Project	IEEE 802.16 Broadband Wireless Access Working Group < http://ieee802.org/16 >	
Title	Clarification on vertically encoded MIMO	
Date Submitted	2005-1-21	
Source(s)	Qinghua Li, Xintian Eddie Lin, Ada Poon, Alexei Davydov, Nageen Himayat, Minnie Ho, Sumeet Sandhu, Uri Perlmutter, Yuval Lomnitz, Randall Schwartz, Jose Puthenkulam Intel Corporation	qinghua.li@intel.com Voice: +1-408-765-9698
Re:		
Abstract		
Purpose	Adoption of proposed changes into P802.16e Crossed-out indicates deleted text , <u>underlined blue indicates new text change to the Standard</u>	
Notice	This document has been prepared to assist IEEE 802.16. It is offered as a basis for discussion and is not binding on the contributing individual(s) or organization(s). The material in this document is subject to change in form and content after further study. The contributor(s) reserve(s) the right to add, amend or withdraw material contained herein.

Clarification on Vertically Encoded MIMO

Abstract

Figure 3 Proposed structure for vertically encoded MIMO.

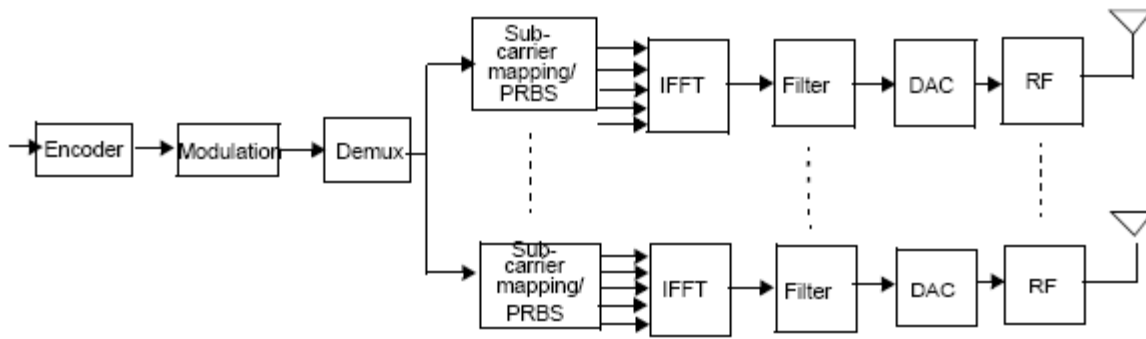
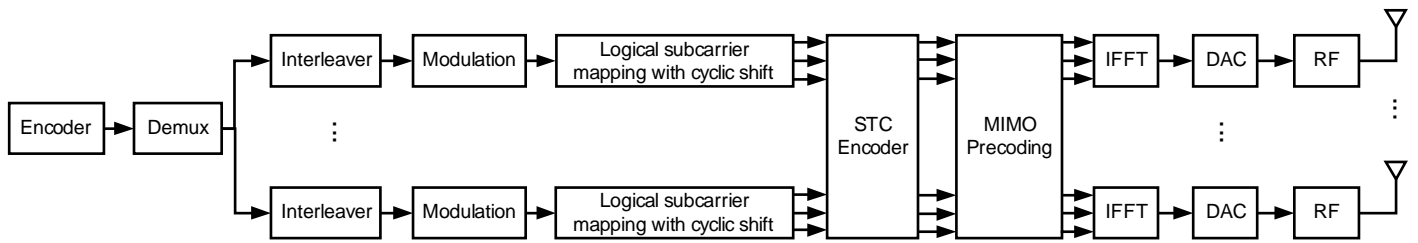
On page 336, D5a, there is an exemplary figure for vertically encoded MIMO, which is shown in Figure 1. The major disadvantages of this structure are as follows. First, new interleavers need to be defined for the increased payload sizes due to parallel spatial channels. For example, the interleaver size at the output of encoder needs to be doubled for two spatial channels. Second, frequency diversity is not maximized because the subchannel allocation for each spatial stream is the same. For example, one FEC block is interleaved and mapped into QAM symbols. The QAM symbols are alternately assigned to two subchannel blocks one per spatial channel by the demux. Because the subchannel allocation is exactly the same on both spatial channels, both subchannels are on the same subcarriers. This means that the FEC block is placed on the same physical subcarriers on both spatial channels. This limitation reduces the frequency diversity if the subchannel doesn't occupy all subcarriers allocated for the user. Frequency diversity can be improved by allowing the logical subchannels on different spatial channels to be placed on different sets of physical subcarriers. Finally, the structure in Figure 1 doesn't support adaptive bit loading because all code bits are mapped to the same modulation constellation before demux. The performance of closed loop is maximized when different modulation orders are employed for different spatial streams. Since the signal qualities on spatial channels can be different by more than 9 dB, which can not be compensated by FEC codes, the weakest spatial channel dominates the performance although there is excess signal power in the strong spatial channels.

We propose slight modifications of the structure in Figure 1. The new structure supports open loop, closed loop, UBL, and ABL, as shown in Figure 3. It doesn't need to define new interleavers for MIMO and employs legacy interleavers designed for single-input single-output systems. The demux in Figure 1 is enhanced to support ABL and a cyclic shift is added at subcarrier mapping block to maximize frequency diversity. The

transmitter works as follows. A block of data bits is first encoded by FEC encoder and the code bits are punctured to achieve a specified code rate. The punctured code bits are distributed to multiple streams according to the modulation orders selected for the spatial channels. It should be noticed that the same modulation order is employed for all subcarrier for a given spatial channel. The distributed bits are interleaved by a legacy interleaver on each channel. The interleaved bits are mapped to QAM symbols and the QAM symbols are mapped to logical subcarriers. The mapped QAM symbols on the logical subcarriers are then circularly shifted by $j-1$ subcarrier for the j -th channel for $j=1, \dots, M$ before they are finally mapped to physical subcarriers. The circular shift allows that the physical subchannel allocations on different spatial channels can be different so that frequency diversity is maximized for the FEC coded block. After the shift, the QAM symbols are STC encoded and may be beamformed. The beamformed symbols are finally mapped to physical subcarriers and are sent by antennas. Detailed description and simulation results of the cyclic shift are in [3]. Detailed operations of the demux are depicted next.

Figure 254a Illustration of vertically encoding for optional zones in DL.

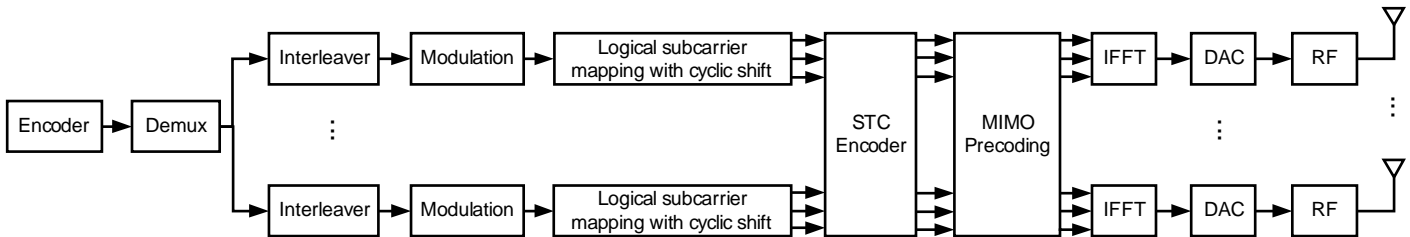
Added section 8.4.8.10 at line 33 on page 362 of [1] as follows

Figure 254a illustrates a transmitter for vertically encoded MIMO, where there are M data streams. The punctured code bits are distributed into M modulation chains by the demultiplexer. The demultiplexer extracts bits for the chains one by one from its input bit sequence. The bits to the chain with higher modulation order are extracted before those with lower modulation order. Denote the number of bits per subcarrier on the j -th chain as L_j , where $L_1 \geq \dots \geq L_M$. The

demultiplexer first extracts the bits for the chain with the greatest modulation order from as follows. The i -th extracted bit is the k -th bit in the original input bit sequence, where $k = \text{round} \left(\frac{i}{L_1} \sum_{j=1}^M L_j \right)$. For the p -th chain, the i -th extracted

bit is the k -th bit in the remaining bits after the extractions for the previous $p-1$ chains, where $k = \text{round}\left(\frac{i}{L_p} \sum_{j=p}^M L_j\right)$.

Each chain interleaves and modulates the distributed bits using the interleaving schemes specified for SISO transmission. After mapped to logical subcarriers, the modulated symbols are circularly shifted by $j-1$ logical subcarriers for the j -th chain for $j=1, \dots, M$. The circularly shifted symbols are then sent to STC encoder.
